REQUEST FOR CITY COUNCIL ACTION

Approval of Resolution 2021-05 Approving Cherry Grove Major Subdivision

CHERRY GROVE SUBDIVISION

RE: Cherry Grove Subdivision
Plan review comments

SHEET TITLE: **ACCESS EASEMENT
(ALLEY) PLAN AND
PROFILE**

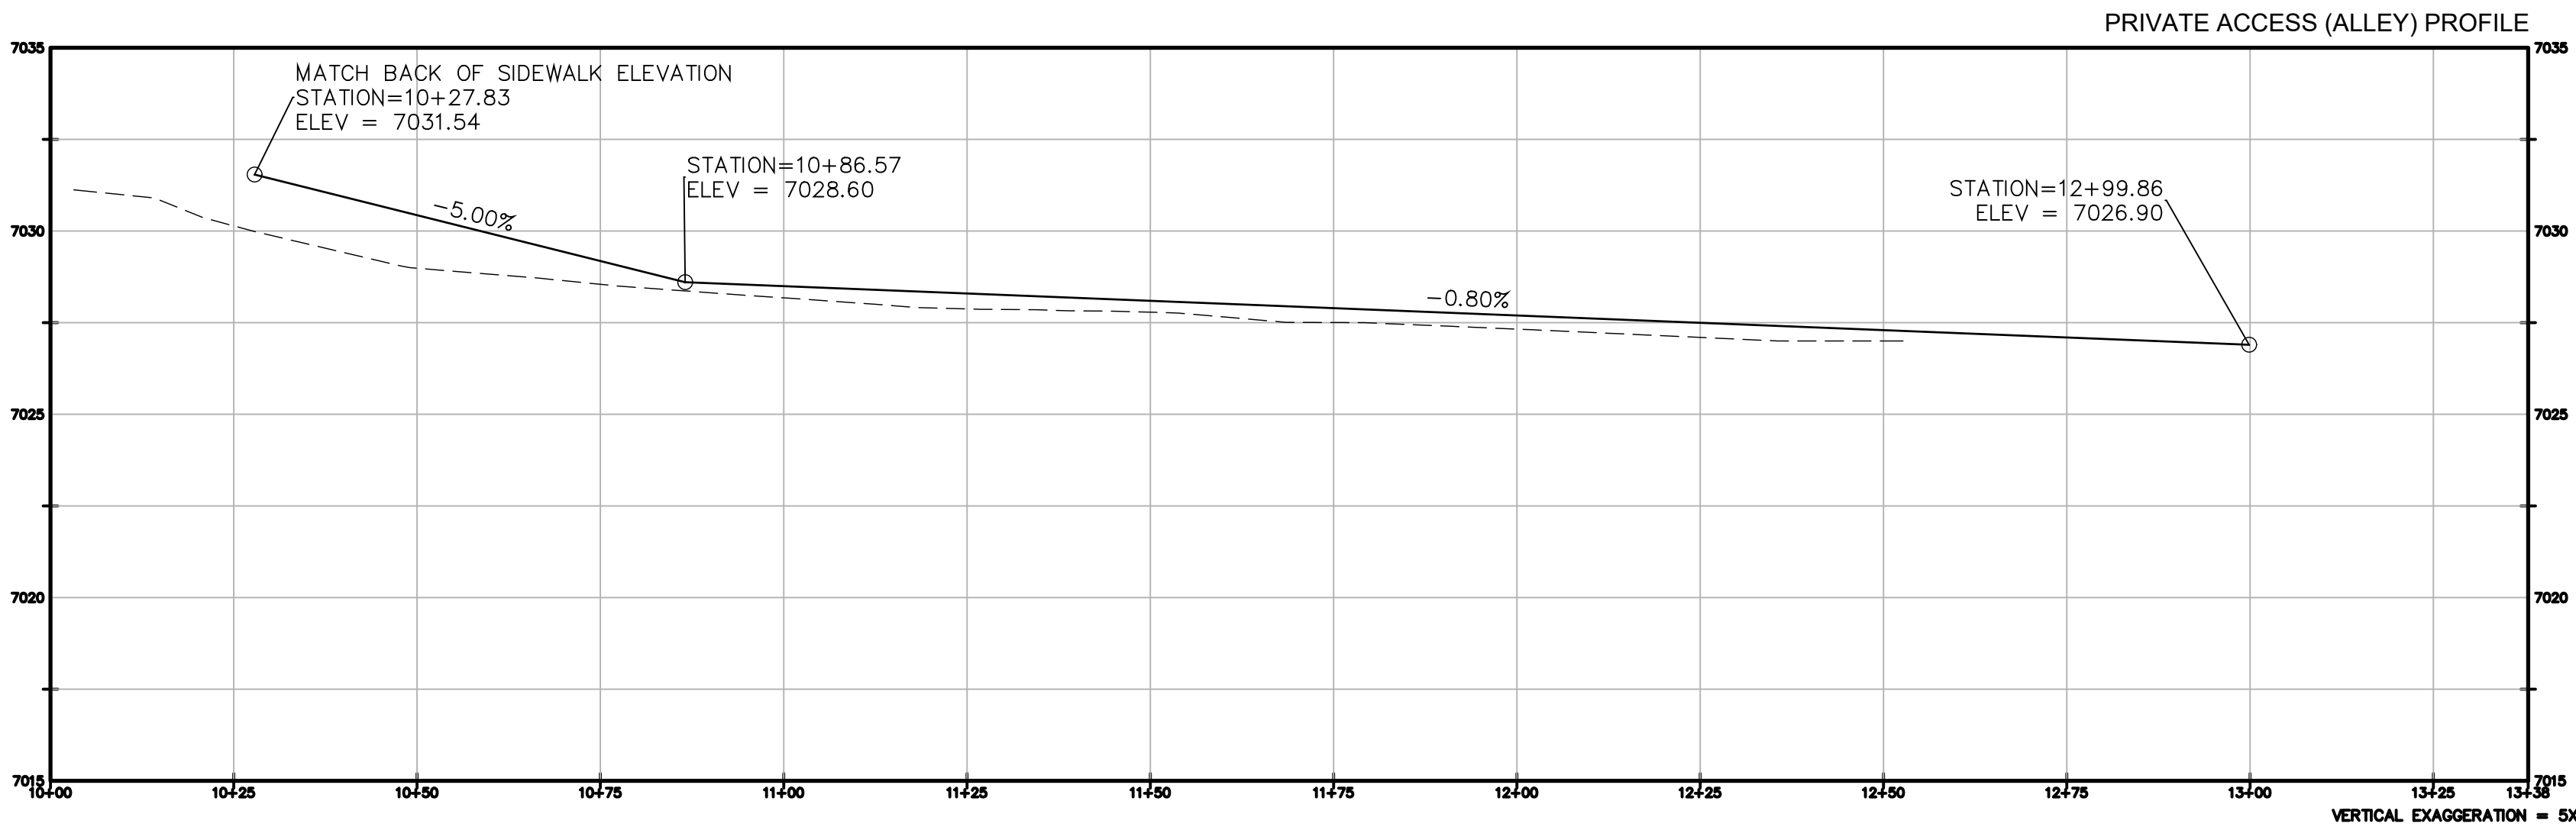
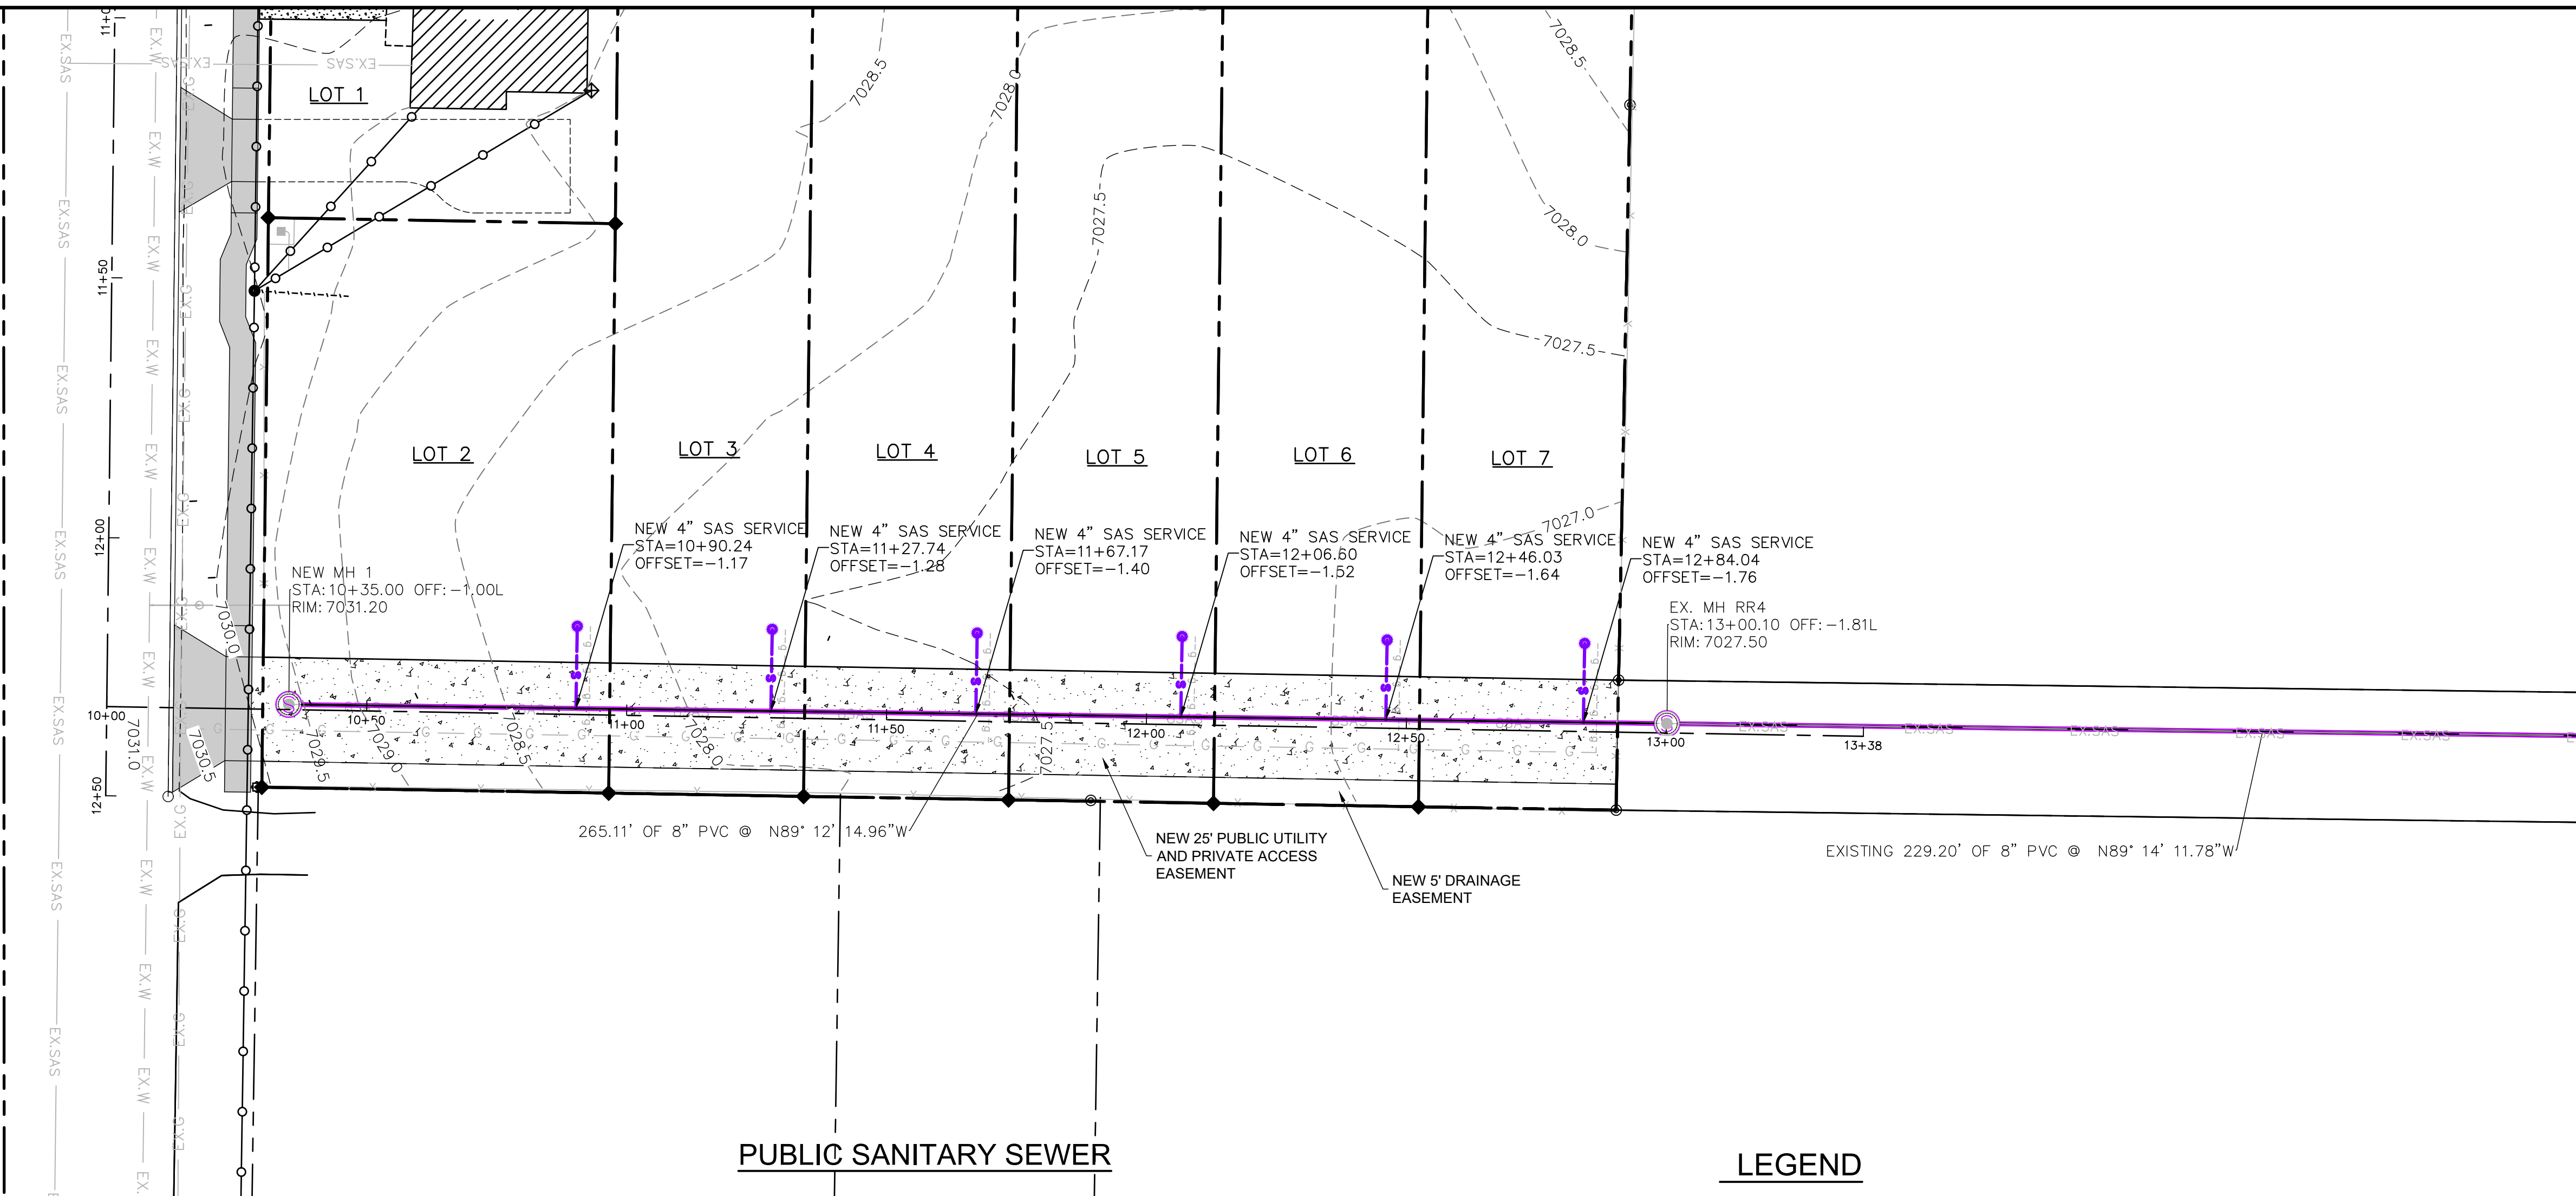
- There are no new public streets within the subdivision. The applicant is providing a 25' public utility easement along the south side of Lot 2 and the rear of Lots 3-7 that connects to the River Ridge Subdivision access and utility easement.
- The applicant is proposing a gate across the easement between the Cherry Grove Subdivision and River Ridge Subdivision. If allowed, the Fire Department requires a Knox padlock for Fire Department access.

- Salida Fire Department: Kathy Rohrich, Assistant Chief, responded "Proposed 20' wide gate will be required to have a knox padlock placed for Fire Department access."
- Salida Police Department: Russ Johnson, Police Chief responded "I have reviewed the plans that have been submitted and have no concerns at this time."
- Chaffee County Development Services Department: No response.

6. The applicant is required to submit, for recordation, a Home Owners Association Agreement (HOA) to maintain the gate and motorized access/utility easement.

6. The applicant is required to submit, for recordation, a Home Owners Association Agreement (HOA) to maintain the proposed gate and motorized access/utility easement.
